NINE MILE POINT  
NUCLEAR STATION

**SUBJECT:** Nine Mile Point Nuclear Station  
Unit No. 2; Docket No. 50-410

License Amendment Request Pursuant to 10 CFR 50.90: Standby Liquid Control System – Increase in Isotopic Enrichment of Boron-10

# **ENCLOSURE**

Figure 3.1.7-1 (Page 1 of 1)  
Sodium Pentaborate Solution Volume/Concentration Requirements

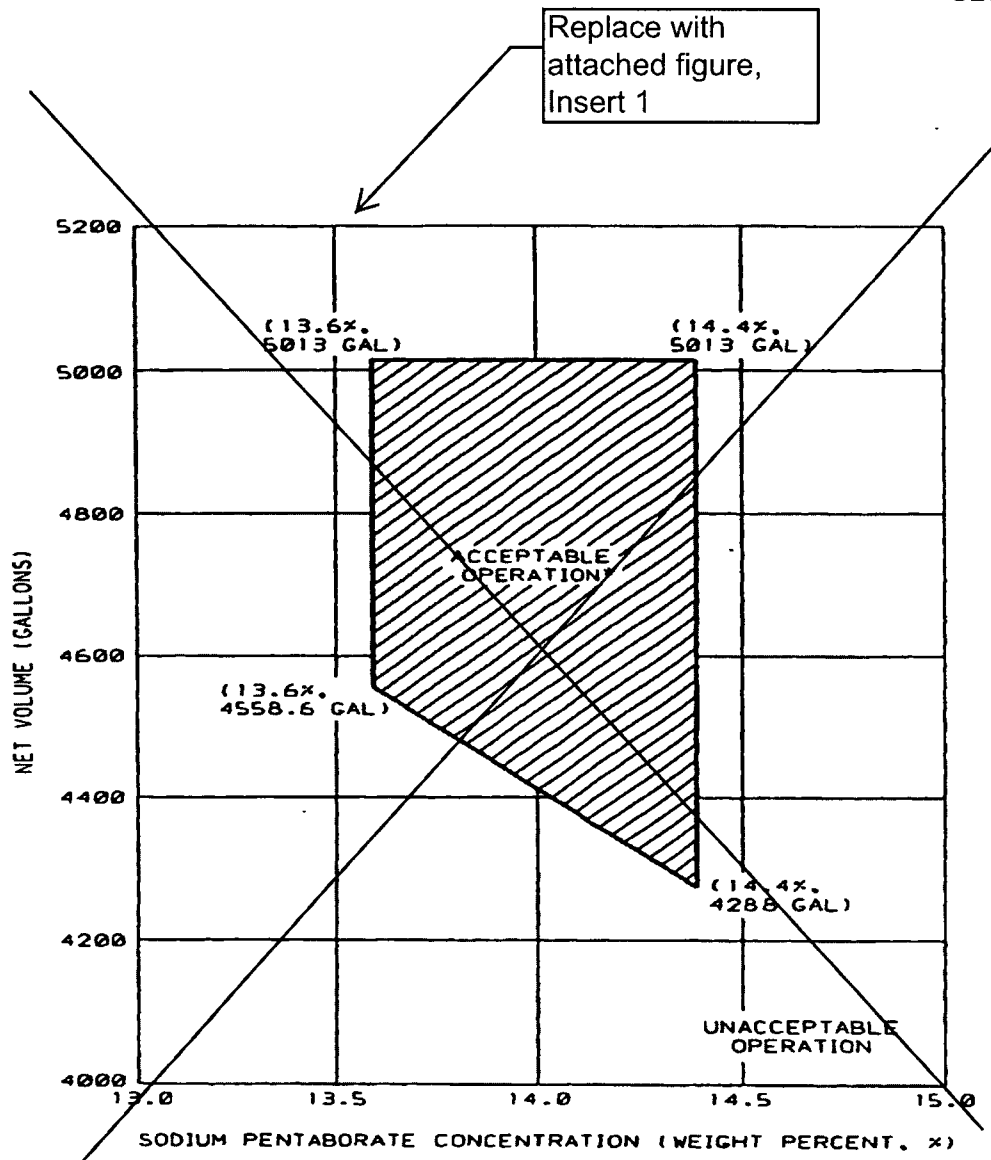
Replace with  
attached figure,  
Insert 1

TS Insert 1 - Figure 3.1.7-1

\*For Boron-10 Isotope Enrichment  $\geq 25$  Atom Percent

TS Figure 3.1.7-1, sodium pentaborate Solution Volume/Concentration Requirements, is revised to account for the change in the minimum volume in the SLC System tank that arises from the enrichment increase. At a sodium pentaborate concentration of 13.6% the minimum volume changes from 4,558.6 gallons to 1,600 gallons. At a sodium pentaborate concentration of 14.4%, the minimum volume changes from 4,288 gallons to 1,530 gallons.

The proposed boron-10 enrichment value allows the minimum solution volume stored in the SLC System storage tank to be decreased to 1,530 gallons at a sodium pentaborate concentration of 14.4% and 1,600 gallons at a sodium pentaborate concentration of 13.6%. The mark-up of NMP2 TS Figure 3.1.7-1 provided in Attachment 1 of this Enclosure delineates the proposed change in the minimum SLC System storage tank solution volume.
